ADDENDUM NO. 1

Date: 27 April 2015 Proj. No. 14033/B2
Subject: Creative World School, Innovating Minds

This addendum shall revise and/or clarify the construction documents prepared by Collman & Karsky Architects, Inc. dated January 29, 2015.

- b. Sheet Keynotes N42 and N46 on detail 16/A602 are as follows:

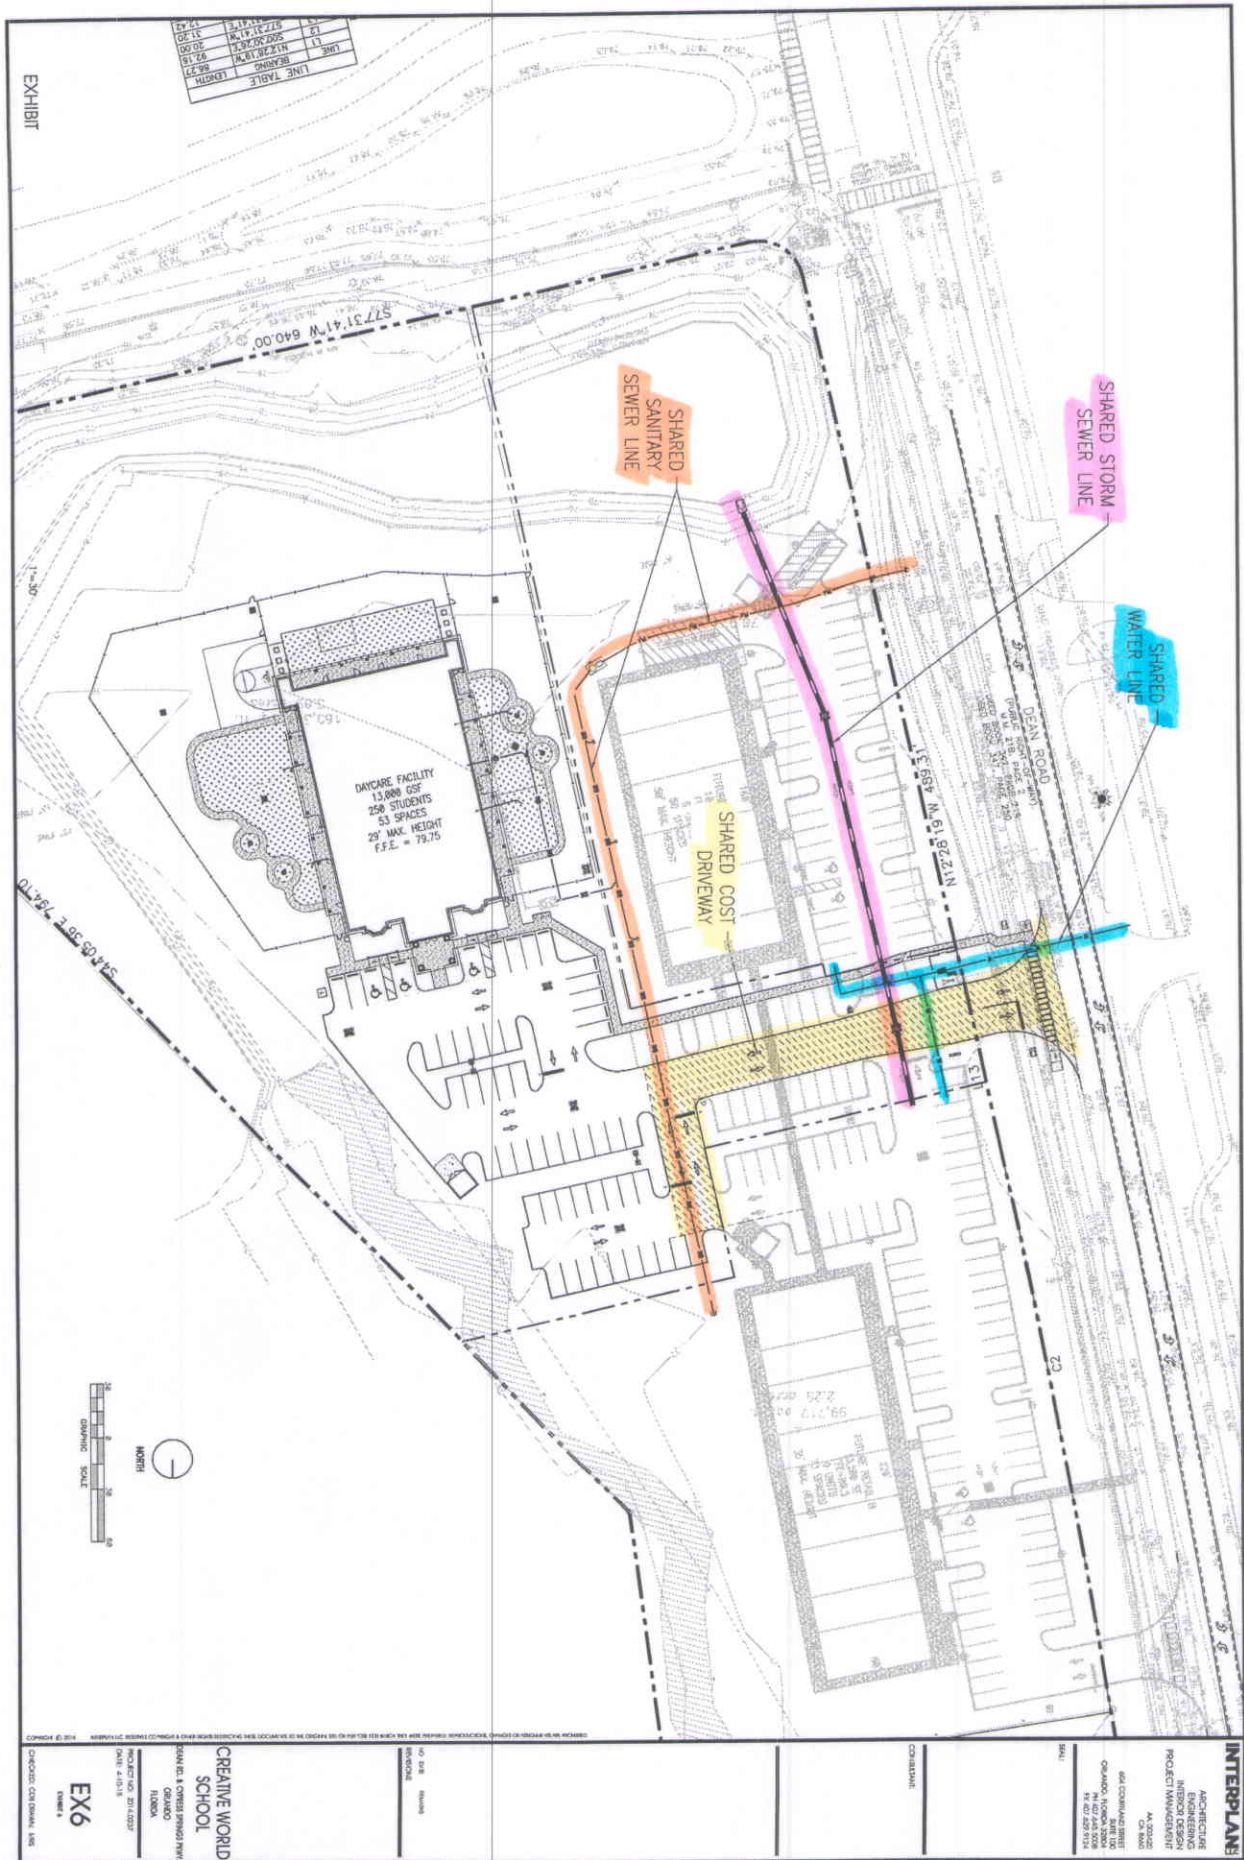
i. N42 CUBBY UNIT BY JONTI-CRAFT, INC. MAPLEWAVE LARGE WALL MOUNT LOCKERS WITH TRAYS MODEL 07710JC011, 48" WIDE, 10 CUBBIES, MAPLE FINISH.

ii. N46 12" DEEP LAMINATE CLAD SHELF WITH SUPPORTS AT 30" O.C.

ELECTRICAL SITE PLAN

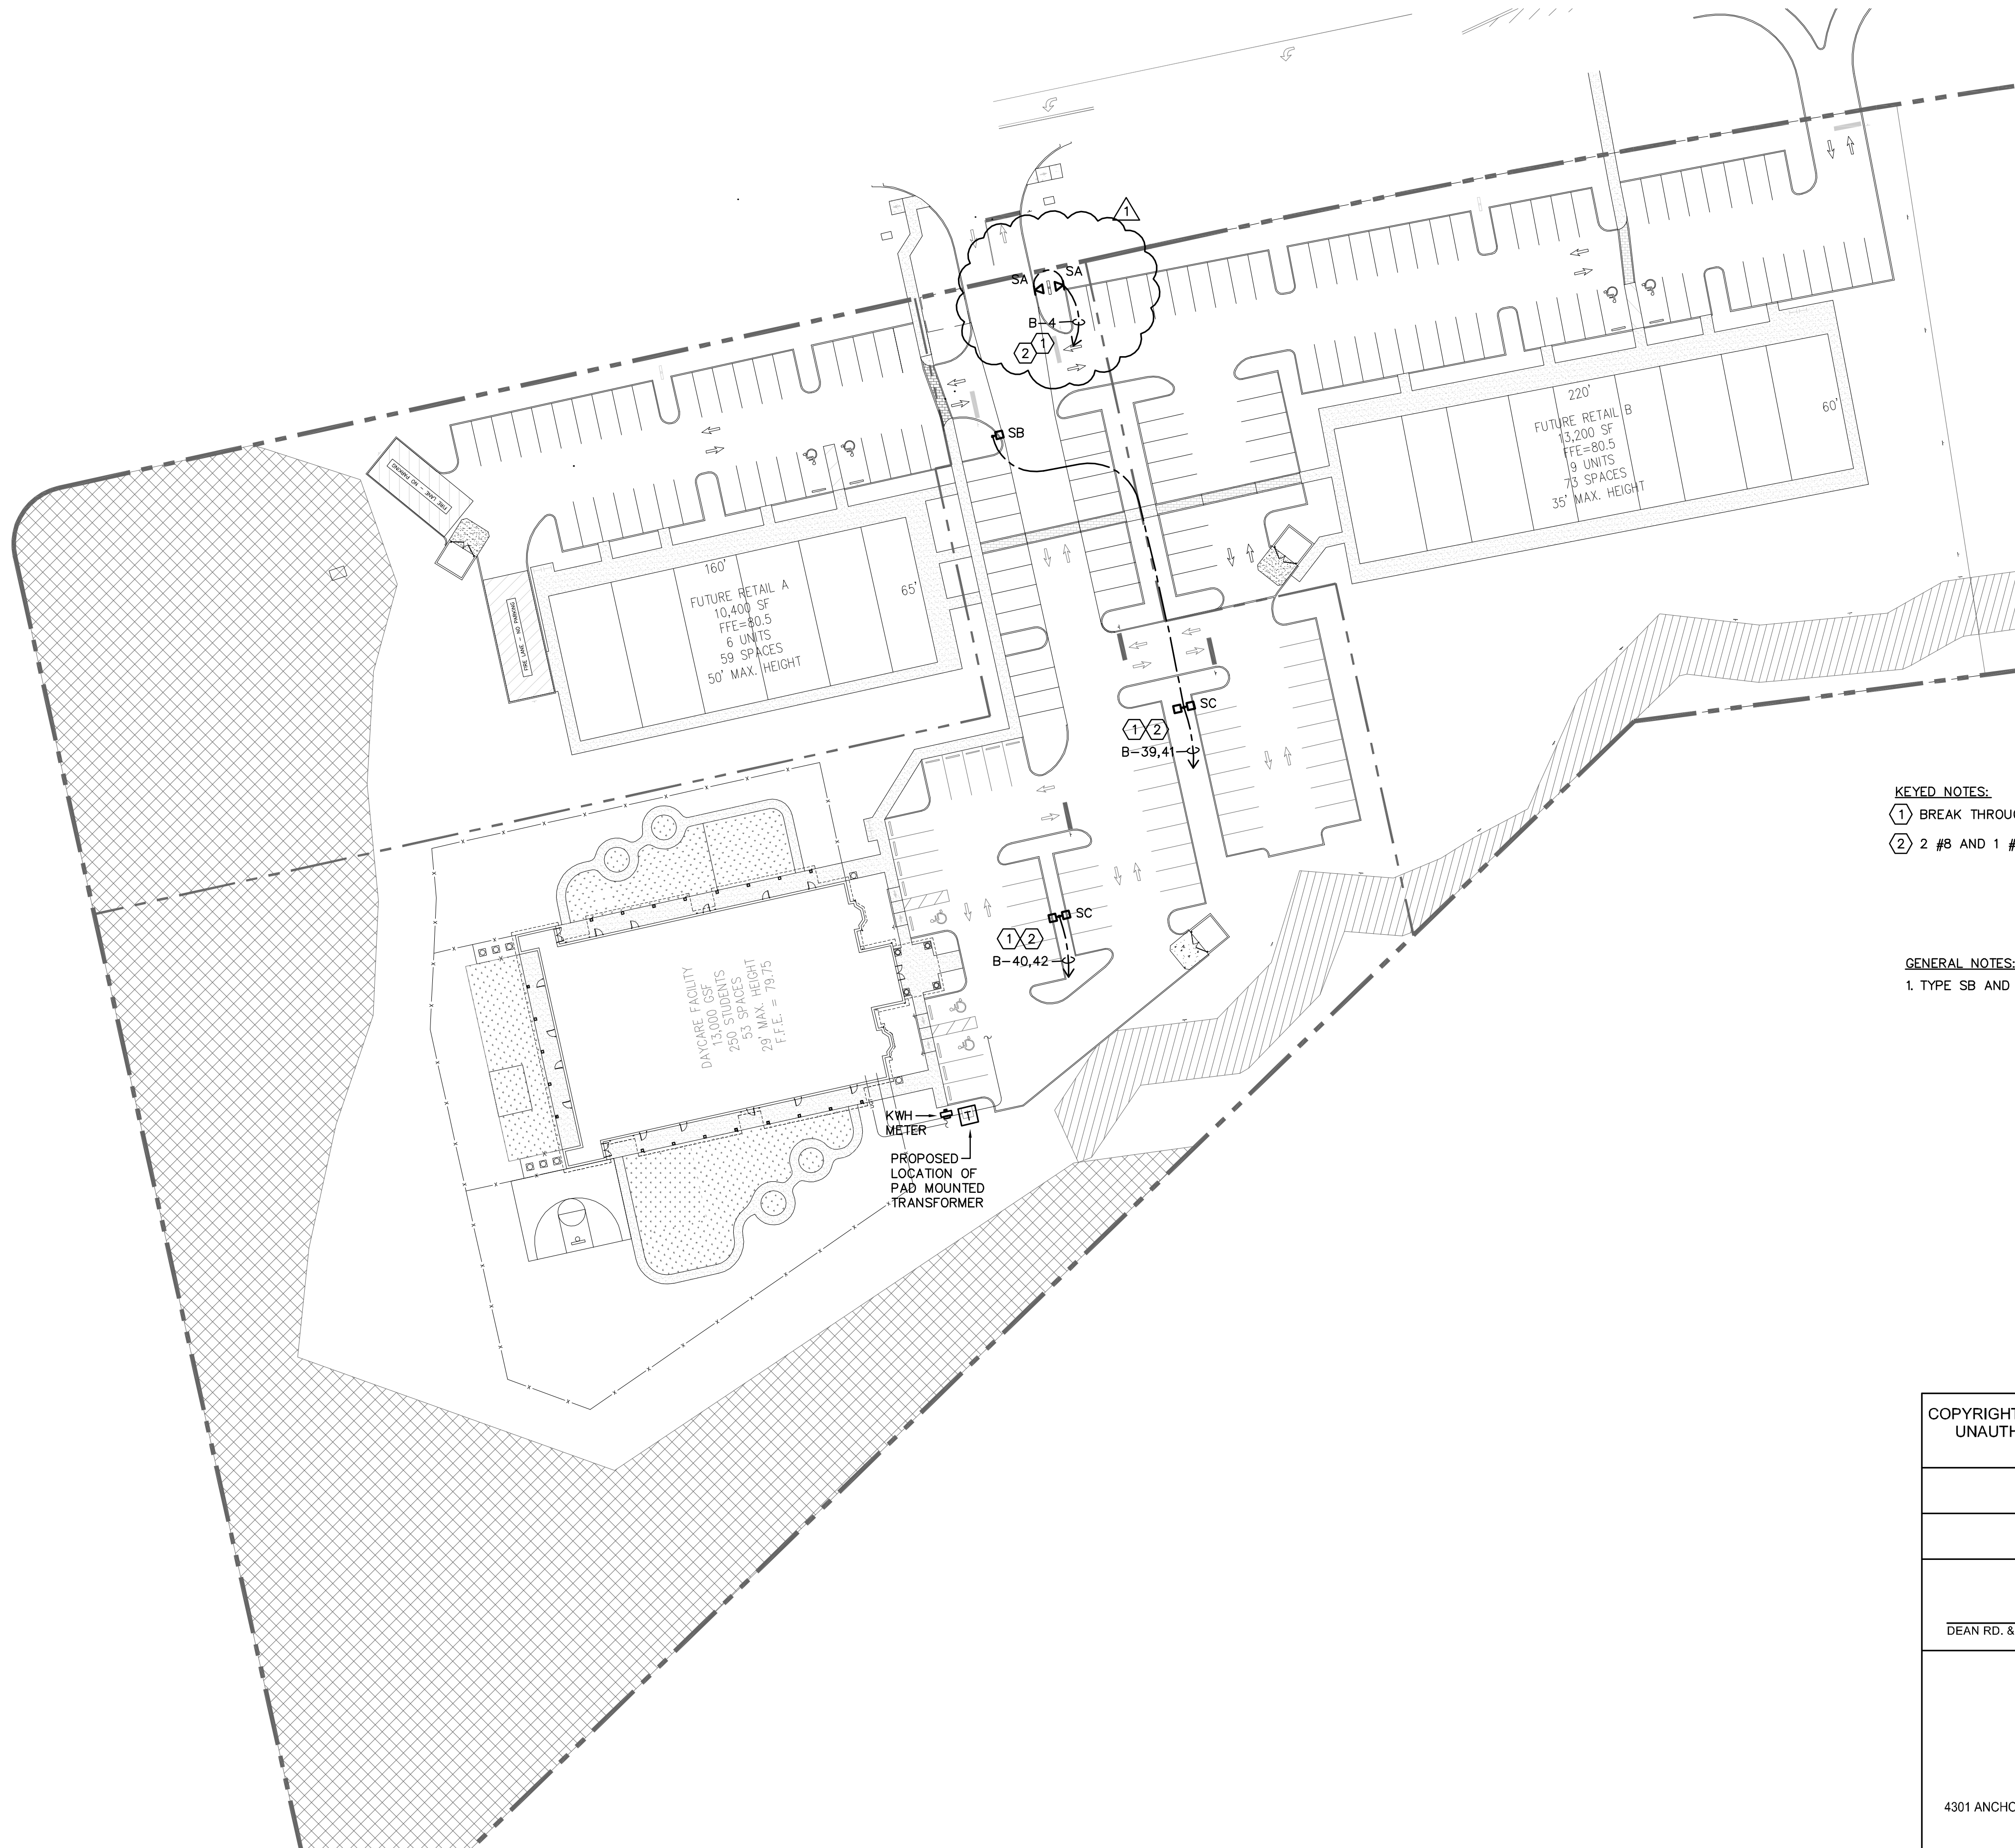
6. Issue revised Electrical Drawing E300-Electrical Site Plan with revision 1 dated 04.27.15.

- KEYED NOTES:**
- ① BREAK THROUGH TIMECLOCK CONTROLLED LIGHTING CONTACTOR FOR CONTROL.
- ② 2 #8 AND 1 #10 E.G. IN 1" CONDUIT.
